# SERVICE INSTRUCTION

**EQUIPMENT: VC-401B**

**SERVICE INSTRUCTION NUMBER: WSI VC-401B-M22-21**

**Revision B**

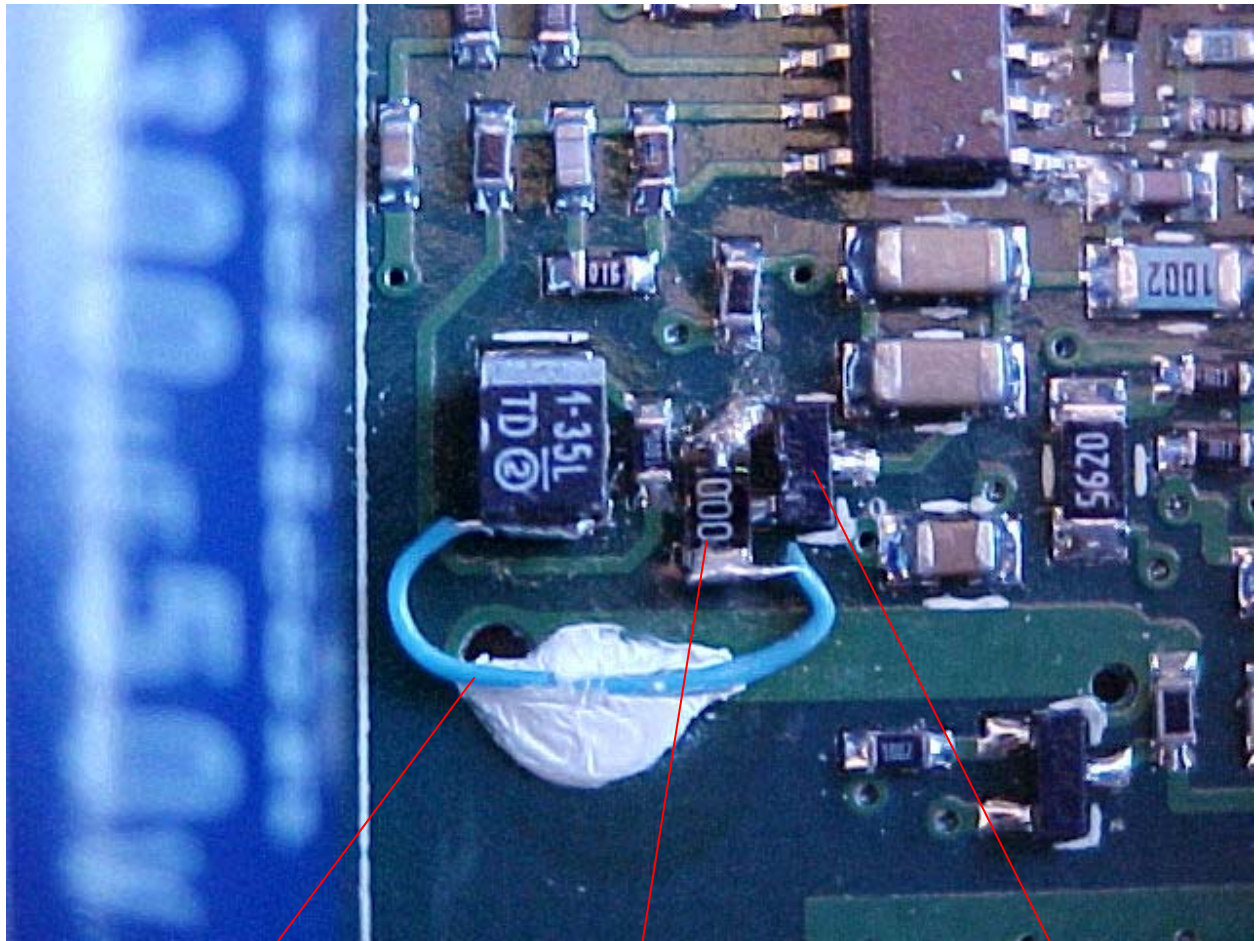
To prevent excessive modulation of the PA at low-end frequencies which varies by voice input modulation.

Install new resistor R410 between the un-terminated leg of CR3 and ground in the PA loop amplifier circuit.

1. Solder a 100 ohm resistor (item 1, R410) to pin 1 of CR3.
2. Solder item 2 or equivalent from R410 to the ground side of C55.
3. Apply MIL-I-46058C compliant conformal coating to newly installed part(s).
4. Identify the unit with the procedure as described and reassemble the unit in reverse order of disassembly.
